Title: MTO2017 Thermostat Oil temperature Sensor Re-positioning		
AG-SB-2021-04-B-EN	Effective Date: 16 June 2021	Compliance Category: A – MANDATORY B – RECOMMENDED C – OPTIONAL
Applicability		
Aircraft type & model: AutoGyro MTO2017	Affected Serial number(s): AutoGyro MTO2017 912/914 fitted with an oil thermostat II incorporating an oil temperature sensor	
The maintenance manual to be referenced is this stated or subsequent issue.		As per AutoGyro website
This form is the response from AutoGyro GmbH either against a problem found in the product in service requiring a containment or rectification action, or as service information for aircraft modification incorporation. For help, contact AutoGyro on 49(0)5121 88056-00, or email airworthiness@auto-gyro.com.

Reason and overview of the Service Bulletin

AutoGyro has developed and released a single thermostat III assembly (47543) and hose set (47422) for the MTO2017 912/914.

Pic. 1

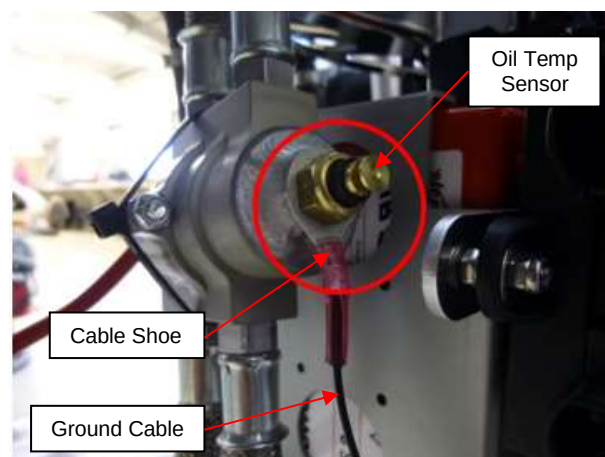
1. Remove the sensor cable from the sensor (Pic. 1) and carefully remove the oil temperature sensor from the old thermostat assembly housing. Heat may be required to release the Loctite bond. Clean/degrease threads using Loctite 7063 (Pic. 2).
2. Cut the cable shoe from the end of the ground cable, protect with heat-shrink and secure suitably (Pic. 2).

Pic. 3

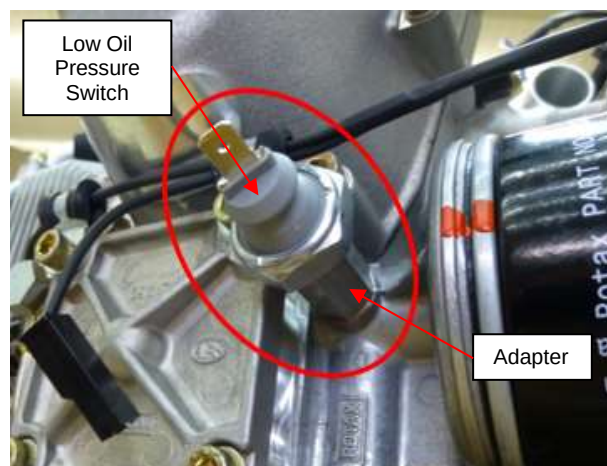
3. Connect the oil temperature sensor cable extension (Pic. 3) to the existing cable and suitably re-route to run across the top of the engine to the rear right side of the engine (the current position of the low oil pressure LED sensor, Pic. 4). Ensure the cable connection is insulated with heat shrink or similar once connected.

4. Remove the low oil pressure LED switch & adapter from the engine (Pic. 4).
5. Remove the switch from the adapter. Clean the threads of the sensor and the (now open) engine mounting position with Loctite 7063. Assemble the switch into the new adapter (Pic. 3) using 1 x copper washer (Pic. 3). NOTE: The adapter has been modified – the item in Pic. 3 is correct, the item in Pic. 10 is the older version.

Pic. 5

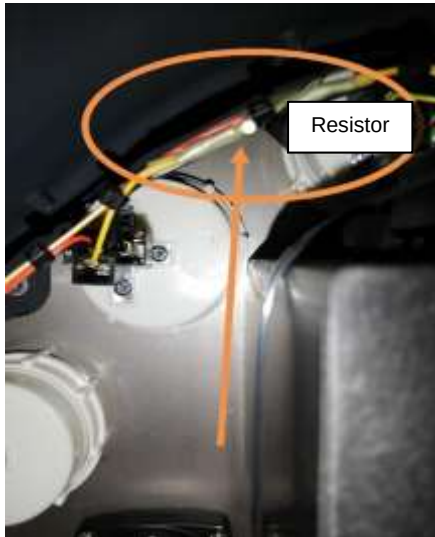
6. Apply Loctite 542 thread sealant to the threads of the temperature sensor and assemble to the engine (Pic. 5).
7. Connect the temperature sensor cable to the temperature sensor (Pic.6).

Pic. 7

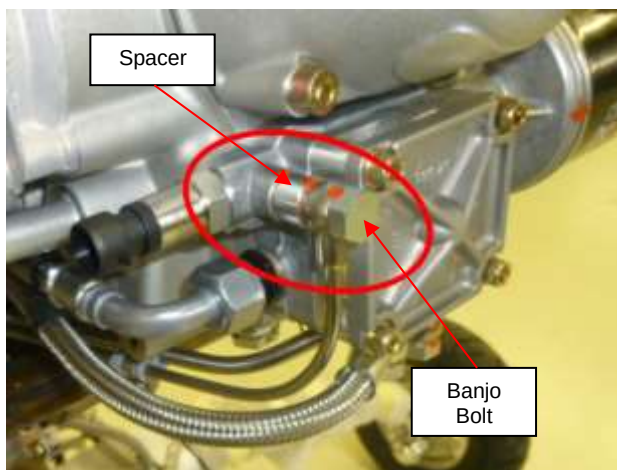
8. It may be the case that the oil temperature gauge has a resistor installed. This can be verified by gaining access to the rear of the instrument and observing if an additional item in the signal wire between instrument and wire is visible (Pic. 7). If this is found to be present, the resistor should be removed and the wire re-joined with a suitable in-line connector.

Pic. 9

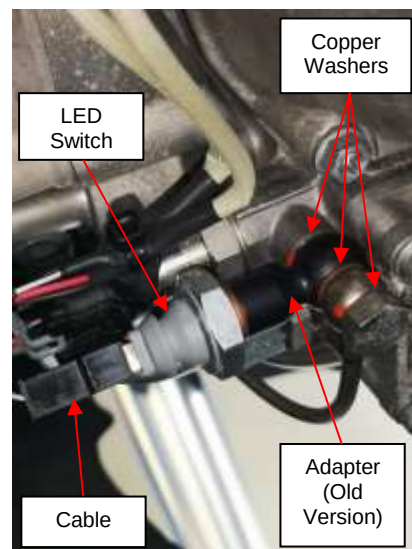
12. Remove the banjo bolt securing the turbo oil line to the oil pump housing (Pic. 9). This item is re-used for the assembly of the low pressure switch.
13. Remove the spacer between housing and oil line (Pic. 9). Clean the internal threads of the housing and banjo bolt using Loctite 7063.
14. Apply Loctite 542 thread sealant to the threads of the original banjo bolt and assemble the pressure switch/adaptor assembly, banjo bolt, oil line and 3 x copper washers (Pic. 10) to the engine. Ensure new copper washers are assembled either side of the adapter and oil line (Pic. 10).
15. Connect the low pressure LED switch extension cable (Pic. 3) to the existing pressure switch cable and suitably re-route between the propeller gearbox and oil pump housings to the new sensor position. Connect to the sensor.
